Plumbing Board Request for Action

NAME OF SUBMITTER		PURPOSE OF REQUEST (check	
Arthur Schwidder		x Code Amendment Repea	al of an existing Rule
The Minnesota Plumbing Code (MN Rules, Chapter 4714) is ava	ailable at <u>http://www.dli.mn.gov/0</u>	CCLD/PlumbingCode.asp.
Specify the purpose of the predefined, check all that apply) X Appurtenance (e.g., water co Other (describe)		or code change for fixture, app	ourtenance, material, or
Does your submission conta	in a Trado Socret2 Ves	v No	
If Yes, mark "TRADE SECRET information. Minnesota Statutes	Γ" prominently on each page o	of your submission that you bel	
method, technique or proc subject of efforts by the in- secrecy, and (3) that deriv	cess (1) that was supplied by to dividual or organization that ar res independent economic value	uding a formula, pattern, comp he affected individual or organi re reasonable under the circum ue, actual or potential, from no by, other persons who can ob	ization, (2) that is the nstances to maintain its t being generally known

SAFL BAFFLE STANDARD DETAIL **UPSTREAM TECHNOLOGIES INC.** 600 COUNTY ROAD D WEST, STE 14 **NEW BRIGHTON, MN 55112** 651.237.5123

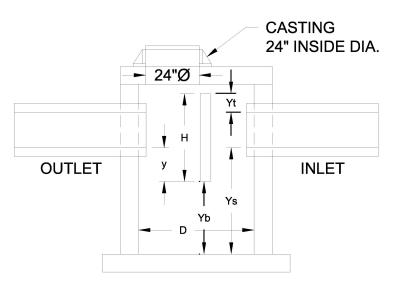
The SAFL Baffle is mounted across the center of the structure, midway between the inlet and outlet pipe. It is typically installed in a 4-foot diameter structure or larger – which leaves more than 18 inches between the inlet pipe and the SAFL Baffle. A typical installation detail is attached.

Preserver™ Dissipator Installation Manual

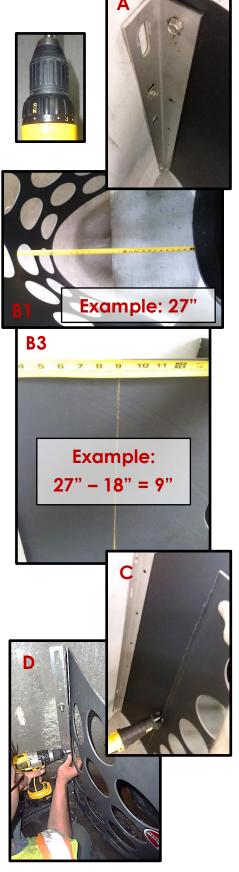
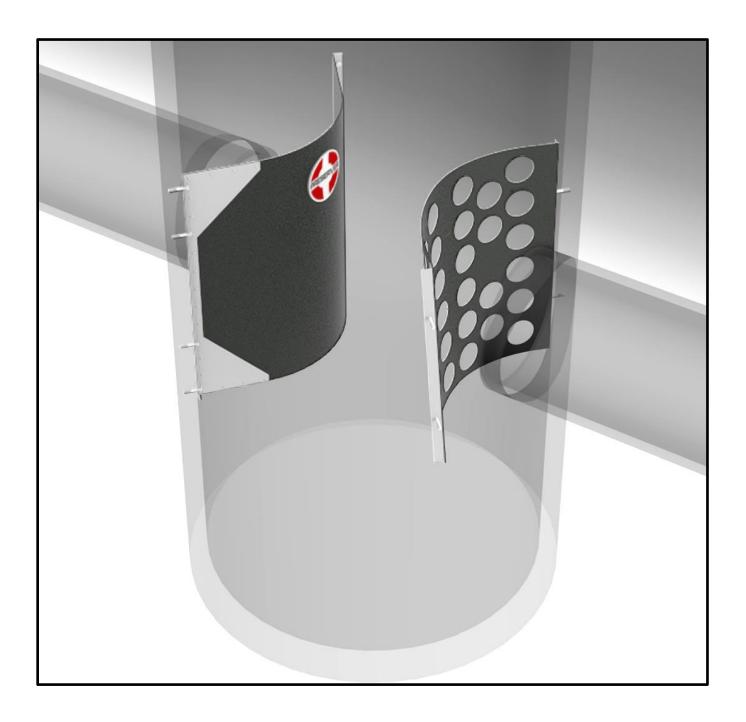
Installation instructions for the Preserver (attached) were revised on April 1, 2019 to show a minimum distance of 18 inches between the inlet pipe and the Preserver dissipator.

- B. Determine the amount of material to remove:
 - 1. Measure the distance from the end of the pipe to the end of the dissipator.
 - 2. From that measurement, subtract the greater of:

- a. 18"
 - b. Half the pipe diameter
 - 3. If that value is 3" or greater, mark the distance on the dissipator from the wall, and draw a vertical cut line.
